Town of Hampden

Agenda

Report on Application
Preliminary Subdivision Plan
Colonial Heights Phase 3

Re: Colonial Heights Phase 3 – Subdivision Plan Application Peer Review

REV:	DATE:	BY:	COMMENTS:
	23 APR 17	JRK	SCALE: 1"=50'
SUBDIVISION PLAN: PRELIMINARY COLONIAL HEIGHTS: PHASE 3			PROJ. NO: 473
CONSTITUTION AVE HAMPDEN, MAINE			
RECORD OWNER: THE CUSHING FAMILY CORP PO BOX 211 HAMPDEN, ME 04444

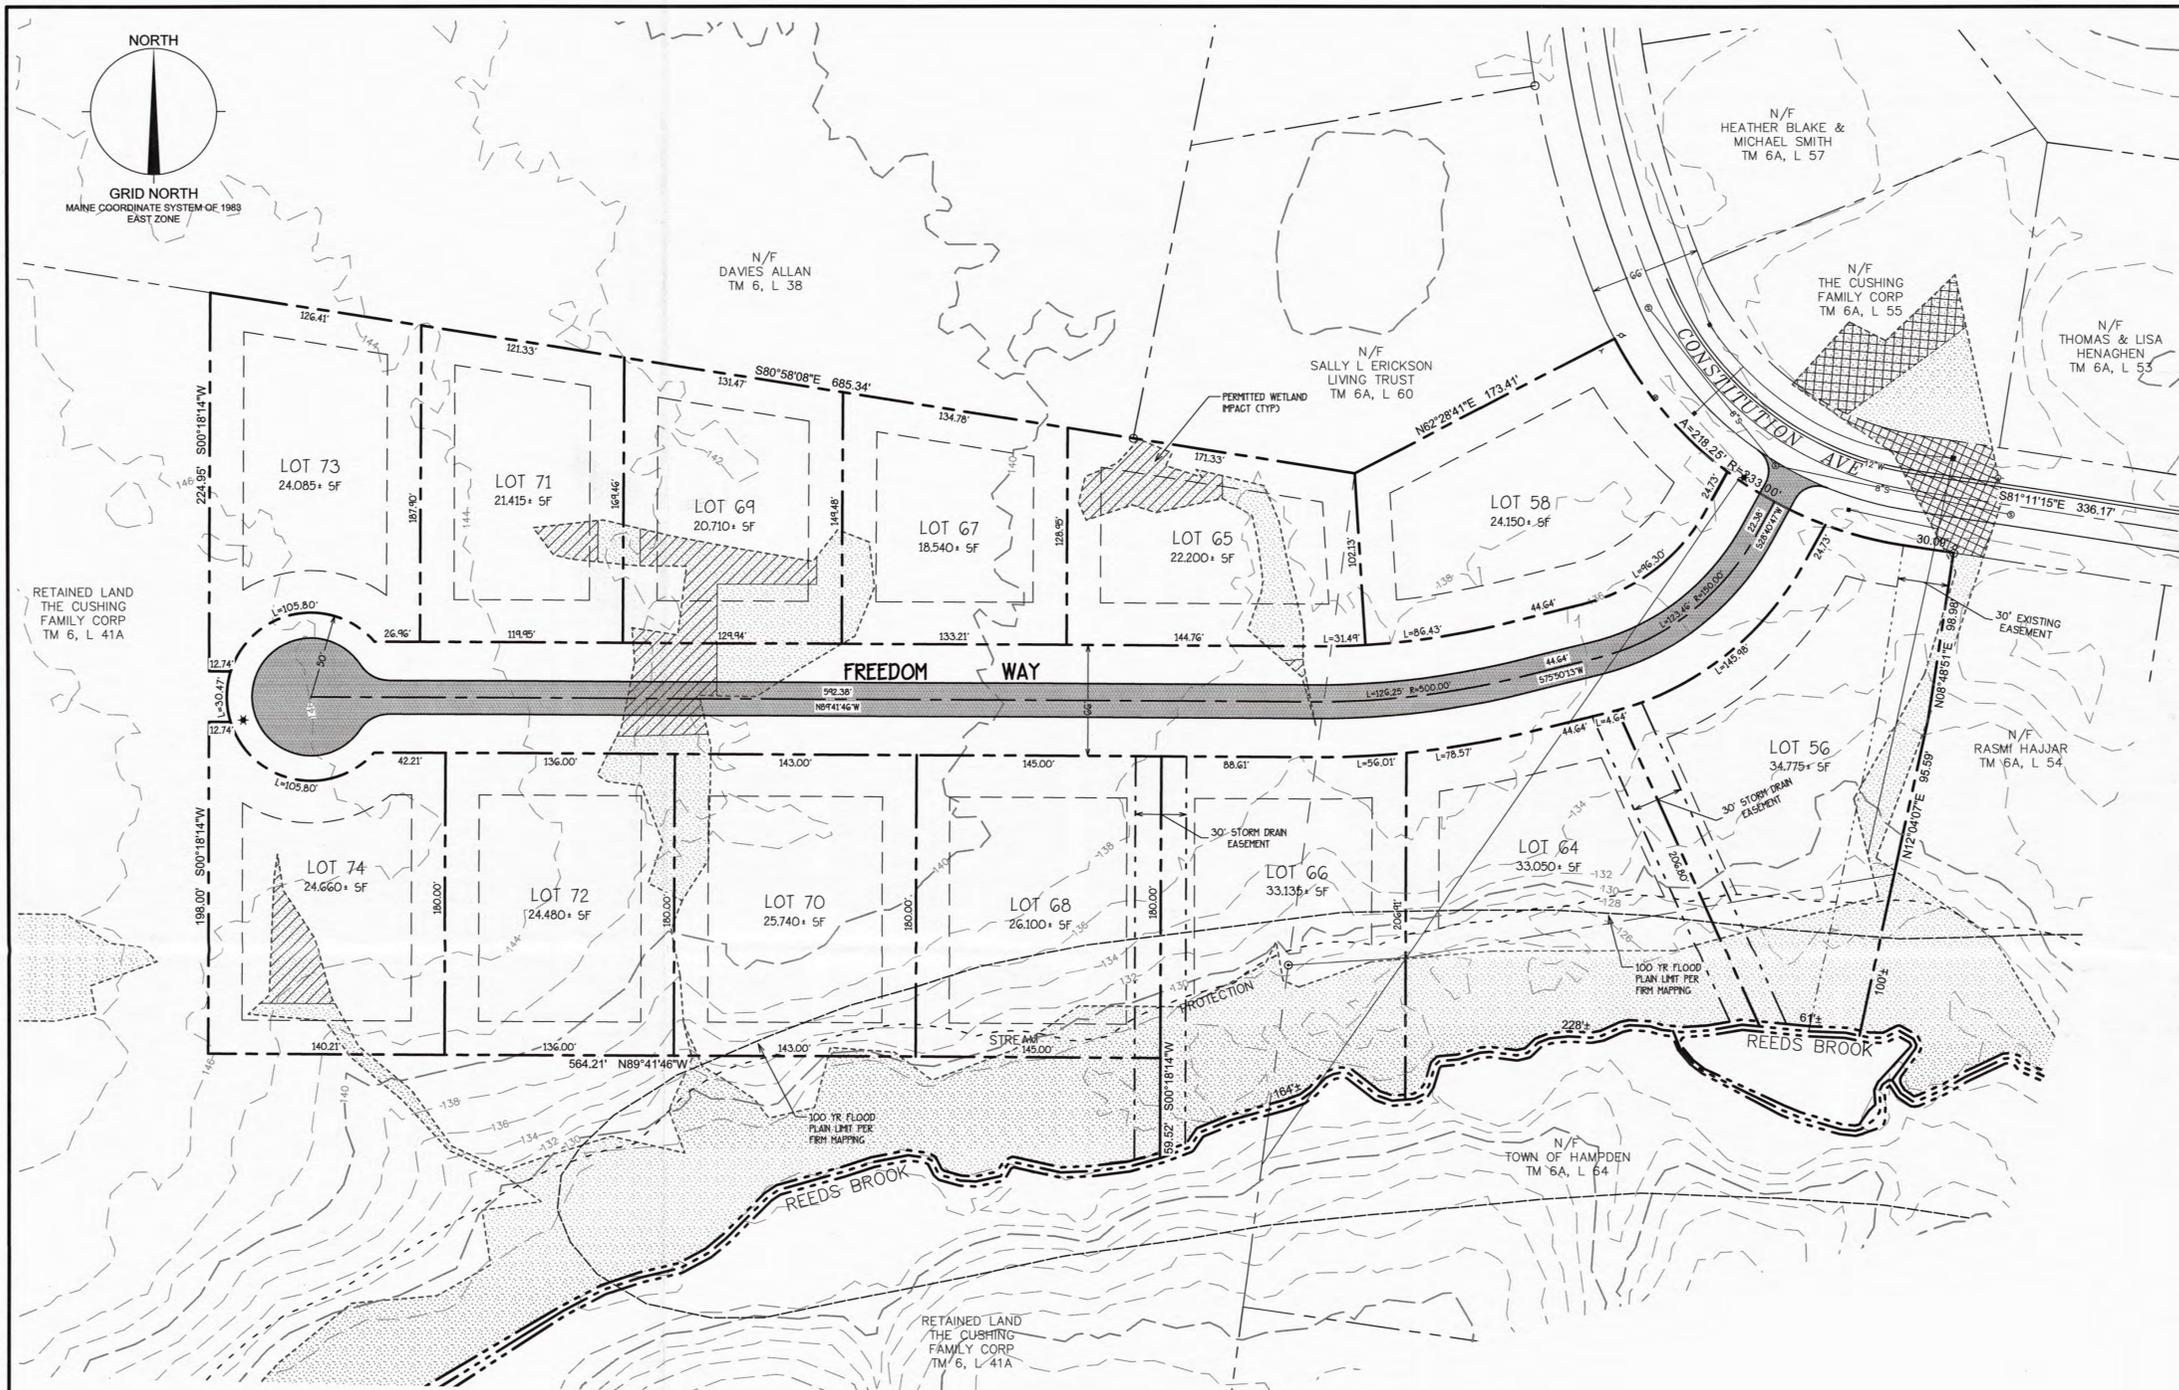
3. The acreage of the parcel to be subdivided is not provided (i.e. acreage of entire parcel 06-0-041-A). In addition, the acreage of the subdivision area is given as 6.1 on the application form and 6.4 in note 3 on sheet 1-1 of the plans. (331.3.2.5) **Plan changed accordingly.**

7. Existing storm drains are not shown on sheet 1-1; existing storm drain on lot 56 per previously approved phase. (331.3.3.8) I assume since the existing water and sewer lines are shown on sheet 1-1, it is meant to show all existing infrastructure. **Plan changed accordingly.**

8. Width of Constitution Ave is not given; width of Freedom Way is only specified in the “residential street section” detail on sheet 2-3. (331.3.3.9) **Plan changed accordingly.**

9. Note 6 on sheet 1-1 is incomplete; also no evidence that the contours are referenced to USGS datum. (331.3.3.10) **Note on plan changed accordingly.**

3. We have included the area of the parent lot in note 8 and corrected note 3 to 6.1± ac.
4. Abutting property labels have been added to the plan.
5. The Location Map has been submitted as a separate map as noted in item 2 above. The location map on the subdivision plan is for general area reference and is not intended to comply with the Location Map criteria of the ordinance.

7. Existing storm drains are now shown on the Subdivision Plan, sheet 1-1.
8. The width of the right of way for Constitution Ave and Freedom Way are now shown on the Subdivision Plan.

9. Note 6 in the General Notes has been updated to include the survey datums.
10. No sidewalks are shown on the plans as there are no sidewalks within the past subdivision phases. A waiver request is included.

BASEMENT FLOORPLAN

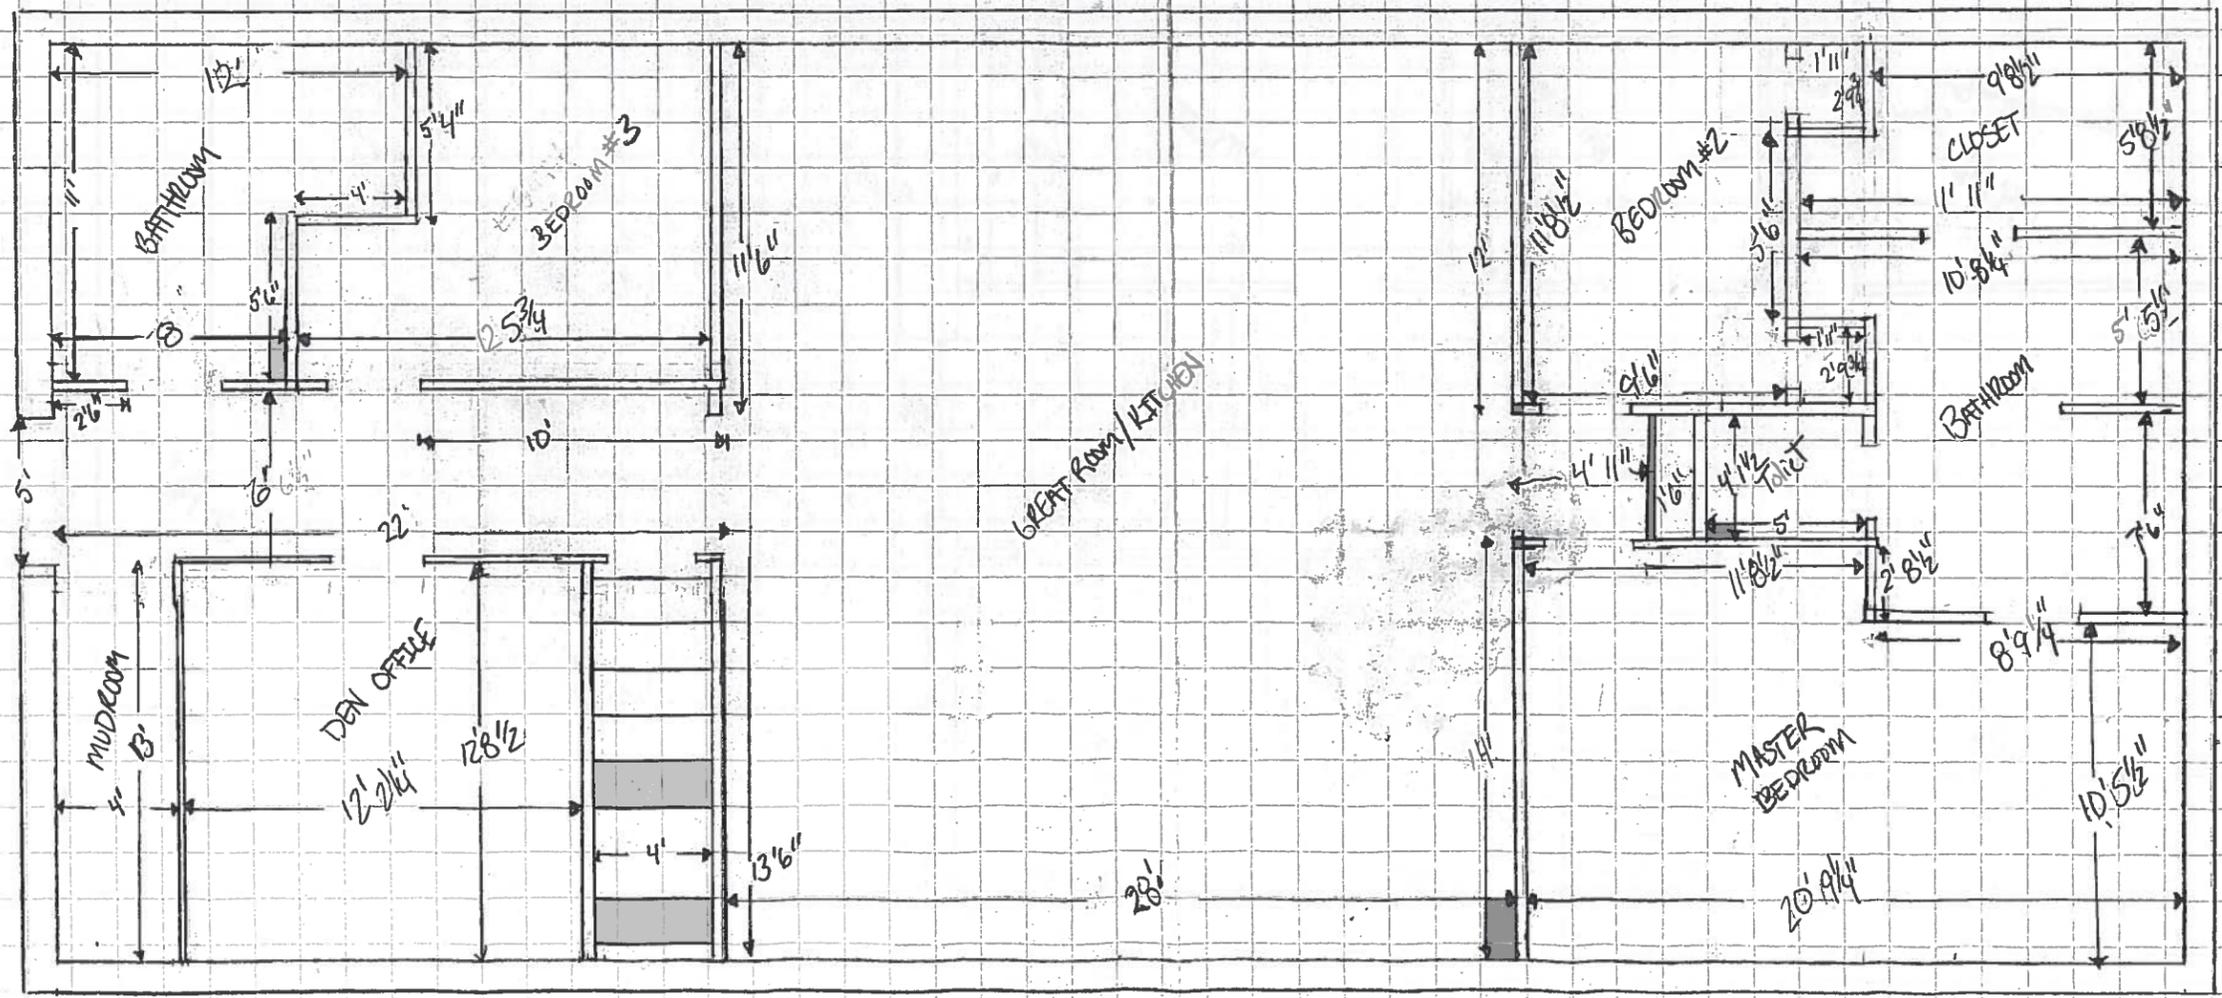
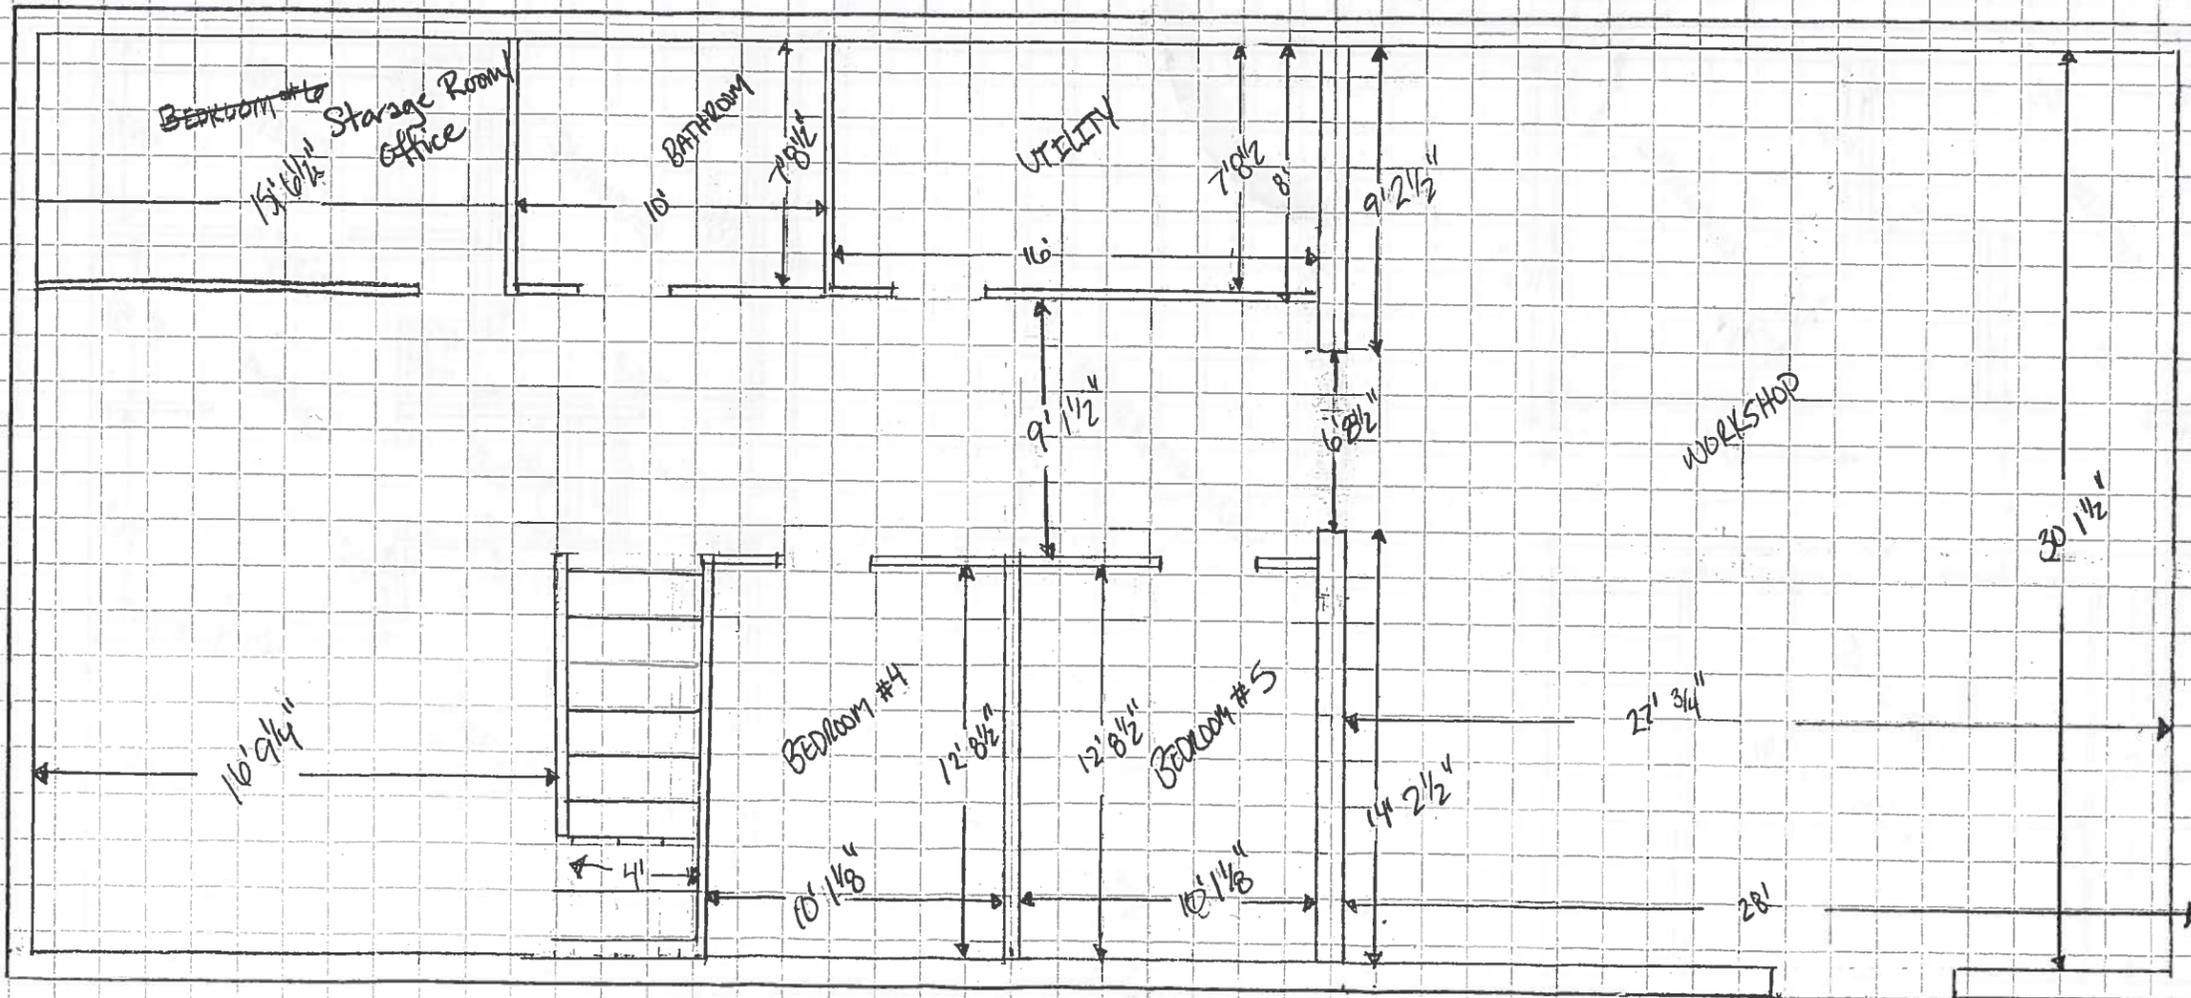
NOTE: This plan will be changed to show a maximum of four bedrooms to comply with the approved (and installed) septic system.

In review of the original building permit it was noted that the basement ceiling/first floor is built out of 1/2" Sheetrock, 22" Floor Trusses, and 3/4" AdvanTech Floor Sheathing. Section R302.3 in the 2009 International Residential Code requires a 1-hour separation between Two-Family Dwellings. In discussion with Fire Inspector Jason Lundstrom and Building Official Jared LeBarnes this assembly does not meet a 1-hour separation. The addition of another layer of 1/2" sheet rock on the ceiling and a 1-hour fire-door at the stairs would accomplish the separation needed. There may be alternative ways to accomplish this separation requirement and the applicant is encouraged to reach out to Code Enforcement Team to discuss options.
